PLAN COMMISSION AGENDA

Tuesday, February 26, 2019
6:00 PM

PLAN COMMISSION MEETING

Should the Plan Commission recommend approval of the Preliminary Plat for Creekside Estates?

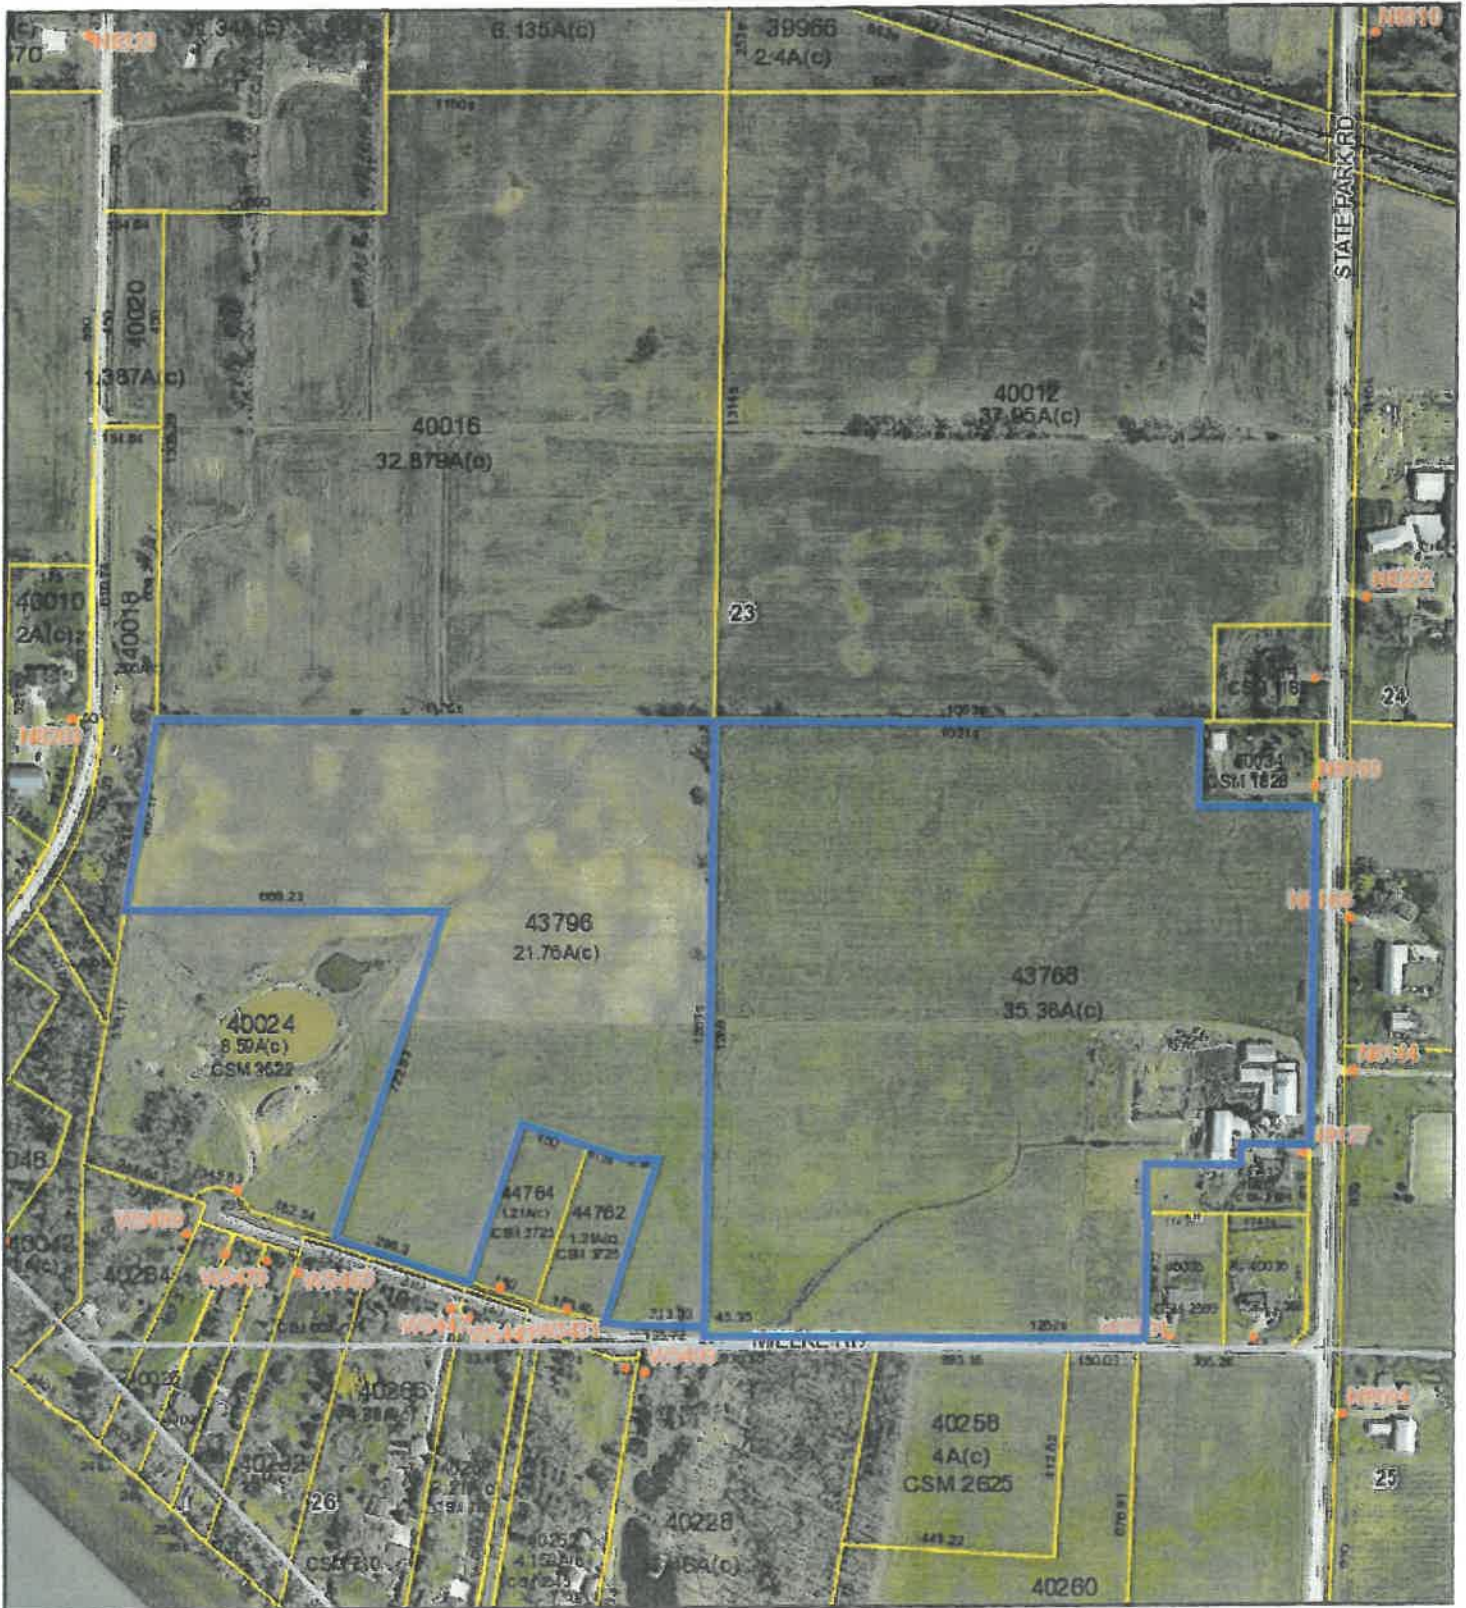
Staff has asked for a grading/drainage plan be developed for all the lots created and being proposed along Mielke Road. This will help ensure that the area develops in an orderly fashion and that future drainage issues are avoided.

Staff recommends approval of the CSM with the condition that a grading/drainage plan be reviewed and approved by the Village.

Should the Plan Commission recommend approval of the Preliminary Plat for Hidden Pines?

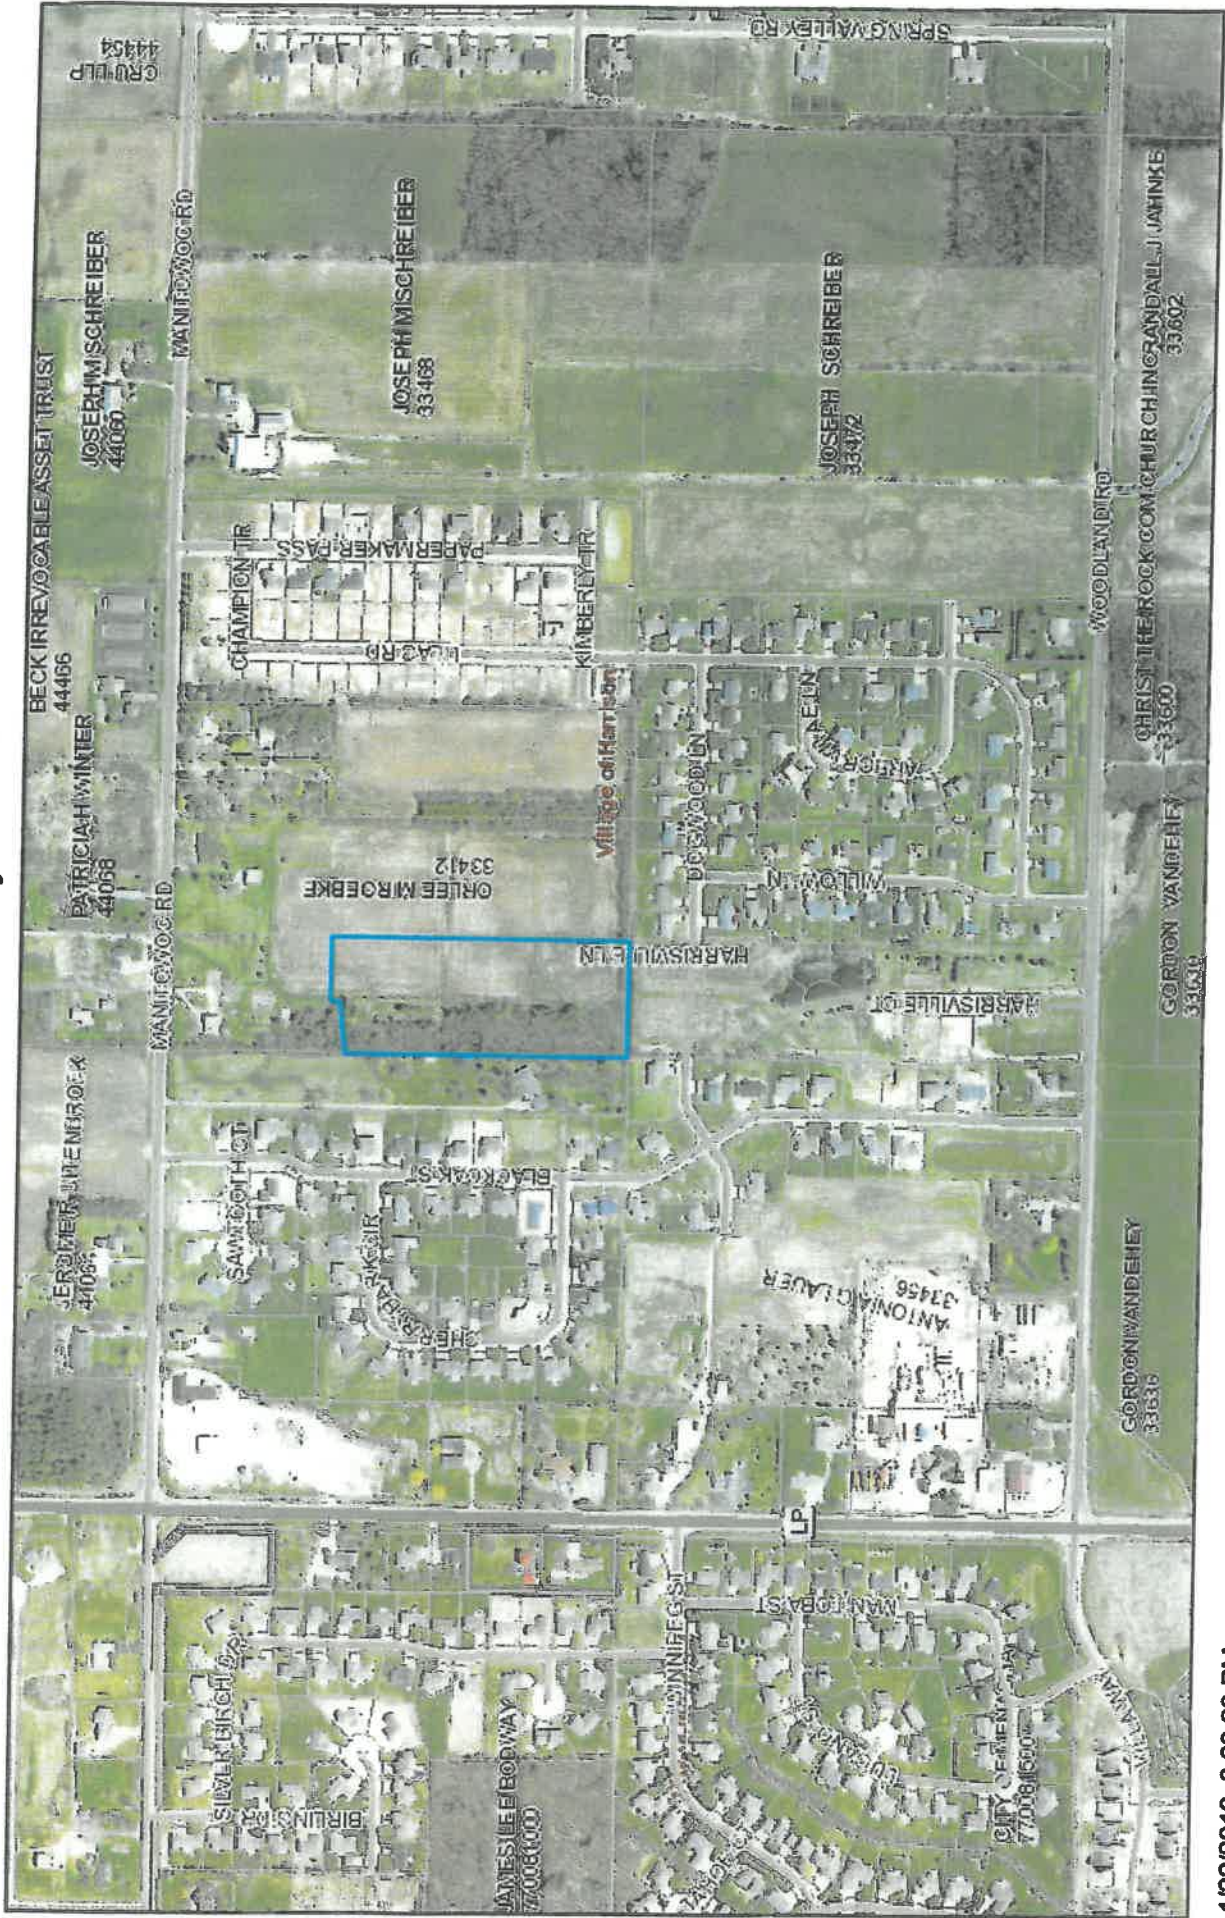
12. Erosion Control Silt Fence shall be installed, in accordance with State Specifications, along the right-of-way line of all streets prior to roadway acceptance.

13. All other improvements, including but not limited to, curb & gutter, concrete paving, sidewalks, shall be installed prior to issuance of building permits or zoning permits, unless the Village Board approves a Subdivision Development Agreement to allow for improvements to be installed at a later date.

14. All comments from the Village engineer shall be included in the Plan Commission discussion and decision.
15. Location of all sidewalk curb ramps shall be approved by Harrison staff.

16. A grading/drainage stormwater management plan and erosion control plan shall be reviewed and approved by the Village engineer and Village staff.
17. Multiple benchmark locations shall be established for use during building construction.

18. All environmental corridors shall be clearly identified and setback lines to be indicated.
19. Grading/Drainage Plan shall identify elevations of ground at the foundation.

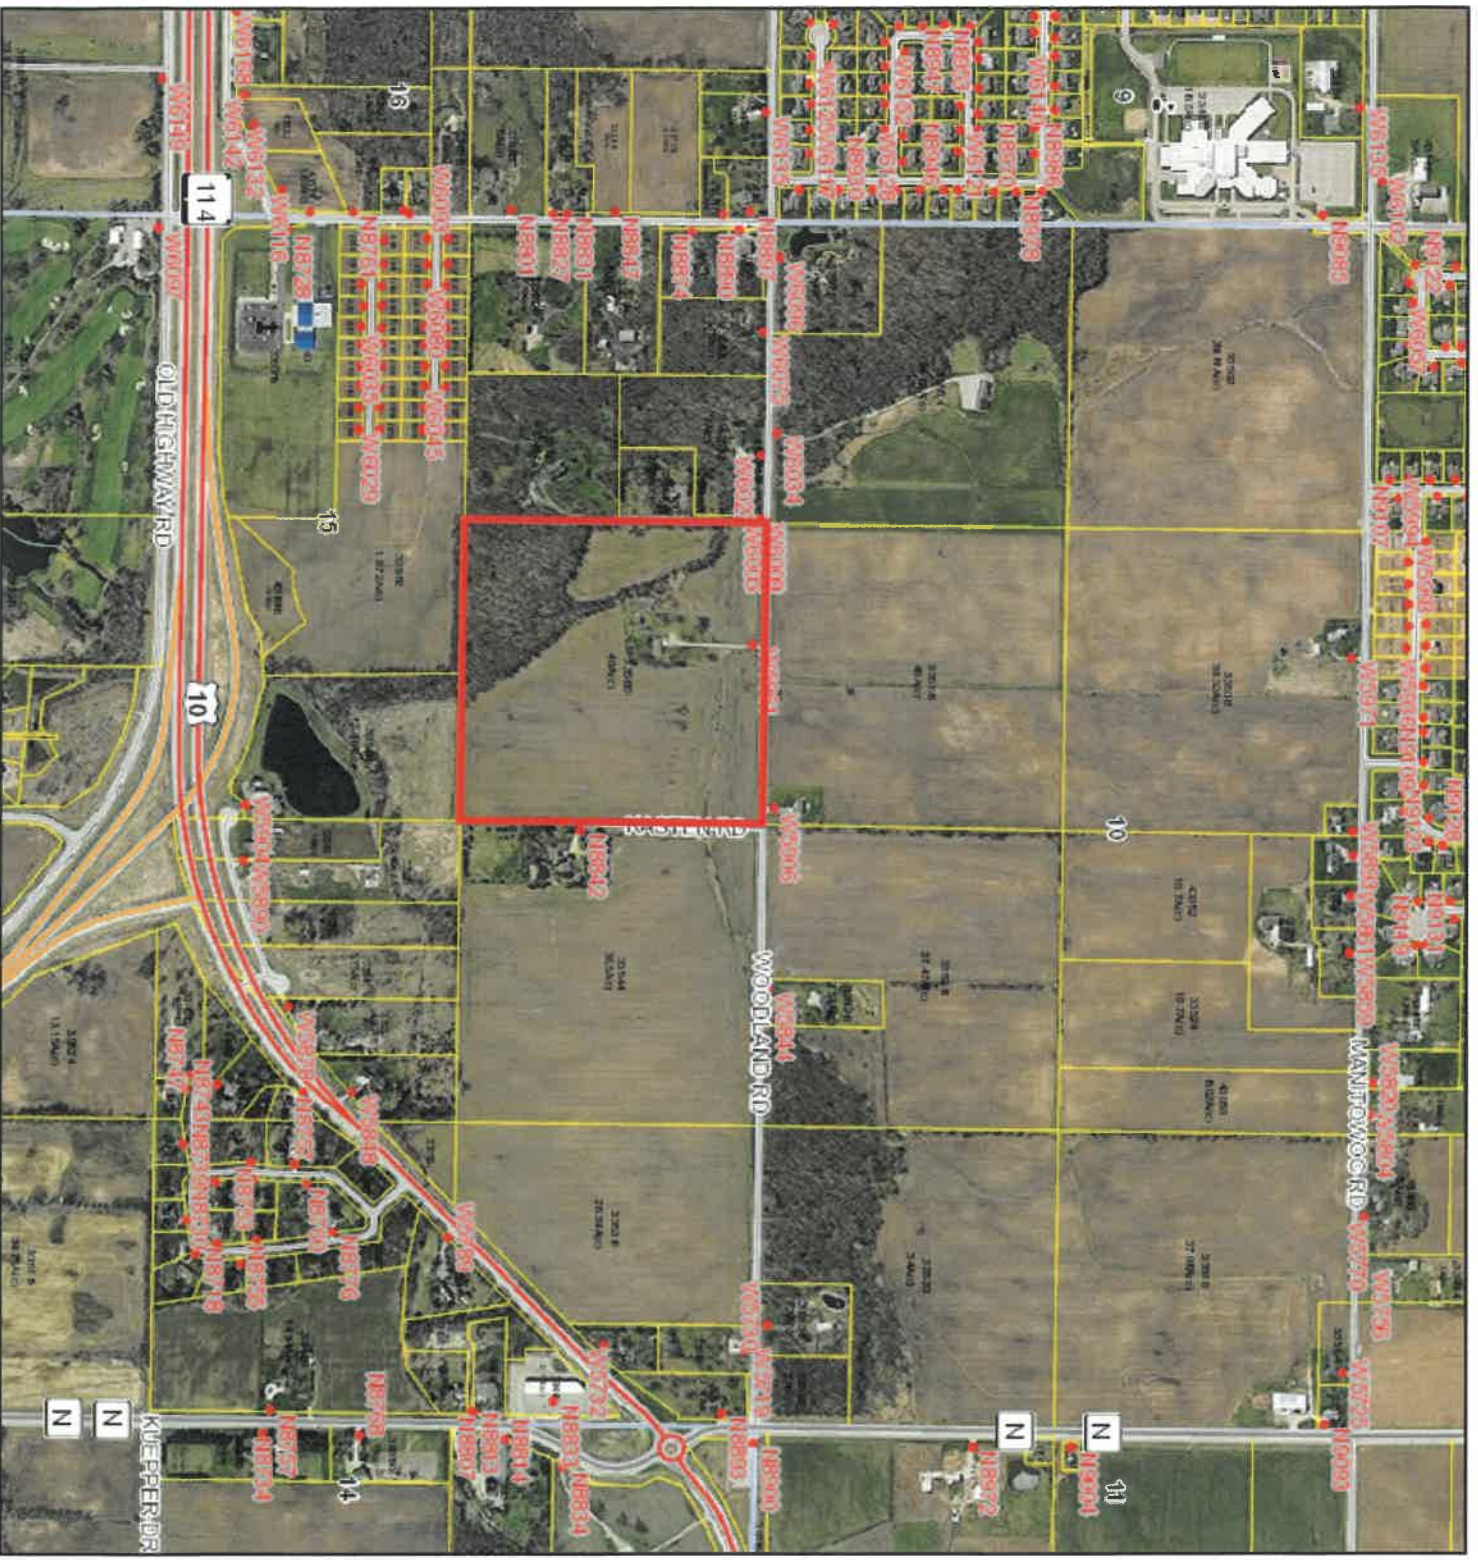
1. A temporary turnaround shall be constructed on the southern stub of Edgewood Lane. The northern stub shall connect to Kasten Road.
2. Tower Drive shall be renamed to Noe Road.
3. Woodland Road to be dedicated with 40-feet of road right-of-way.
4. All lots shall have a storm sewer lateral provided for sump pump discharge.
5. Final utility, street plans, and stormwater management/erosion control plans shall be reviewed and approved by the Village Engineer and Village staff in writing prior to approval of the Final Plat and prior to utility and street construction.
6. A Development Agreement shall be executed prior to approval of the final plat.
7. Parkland dedication or a fee-in-lieu of parkland shall be negotiated as part of the Development Agreement.

8. An assessment waiver shall be signed prior to the approval of the final plat, if there will be any assessments by Village. A note, listing the improvements to be assessed, shall be added to the final plat indicating that the Village of Harrison will assess all lots equally.

9. A street light shall be installed at the intersection of Tower Drive and Woodland Road. Any proposed street lights shall be installed and upfront costs to be paid by the Developer. The Village will assume long-term maintenance.

19. All comments from the Village engineer shall be included in the Plan Commission discussion and decision.
20. Location of all sidewalk curb ramps shall be approved by Harrison staff.

21. A grading/drainage stormwater management plan and erosion control plan shall be reviewed and approved by the Village engineer and Village staff.
22. Multiple benchmark locations shall be established for use during building construction and shall be identified on the final grading/drainage plan.

23. All environmental corridors shall be clearly identified and setback lines to be indicated.
24. Grading/Drainage Plan shall identify elevations of ground at the foundation.
